TECH TIP 003

E2/TT003 v1.0
2014/03

5501XS, 5671XS & RELATED TENSIONERS

RENAULT 1,4 16V & 1,6 16V PETROL

FIG. 1

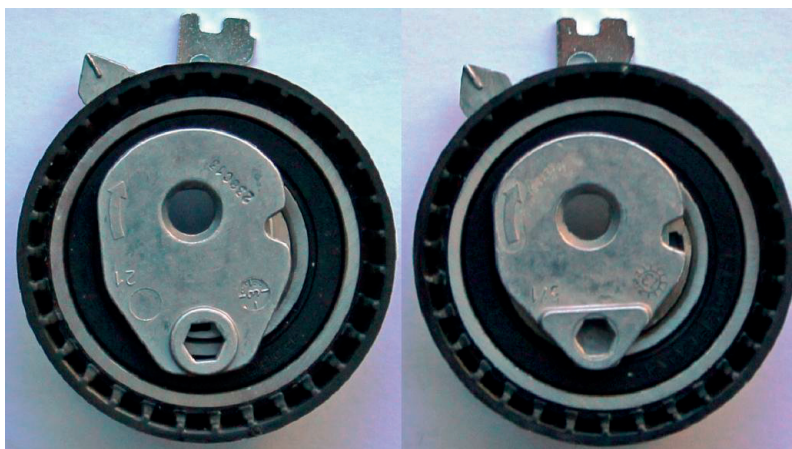
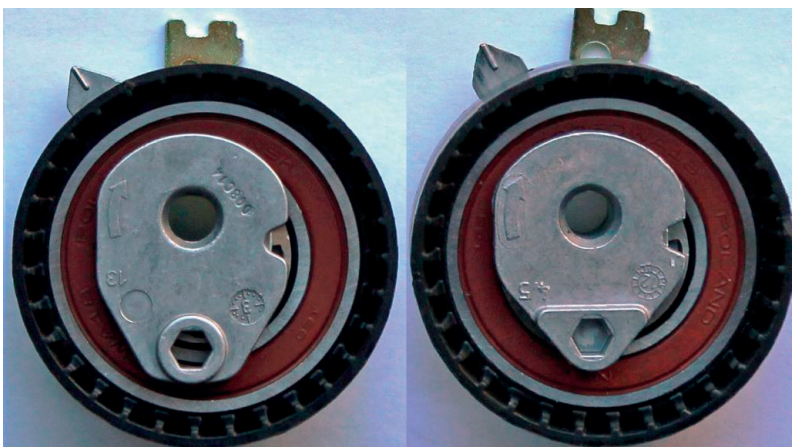
An OEM/OES upgrade has made timing belt 5501XS and the associated tensioners T43064 (Fig. 1 left) or T43168 (Fig. 1 right) as well as the related kits, obsolete. They will no longer be installed on Renault K4M/K4J engines.

Belt 5501XS has been superseded by 5671XS, tensioner T43064 has been superseded by T43236 (Fig. 2 left) and tensioner T43168 has been superseded by T43238 (Fig. 2 right).

All four tensioners appear to be identical, but there is an essential operational difference. New generation tensioners T43236 and T43238 deliver less belt tension and can only be used with the new generation belt: 5671XS, construction designed specifically for this upgrade.

The old belt (5501XS), old tensioners (T43064 and T43168) and kits from your inventory can still be installed on K4J/K4M applications manufactured before 2013. Old generation parts and new generation parts can't be mixed. The new belt (5671XS) may be used on all K4M/K4J applications. However, it must only be used in conjunction with the new generation tensioners (T43236 and T43238).
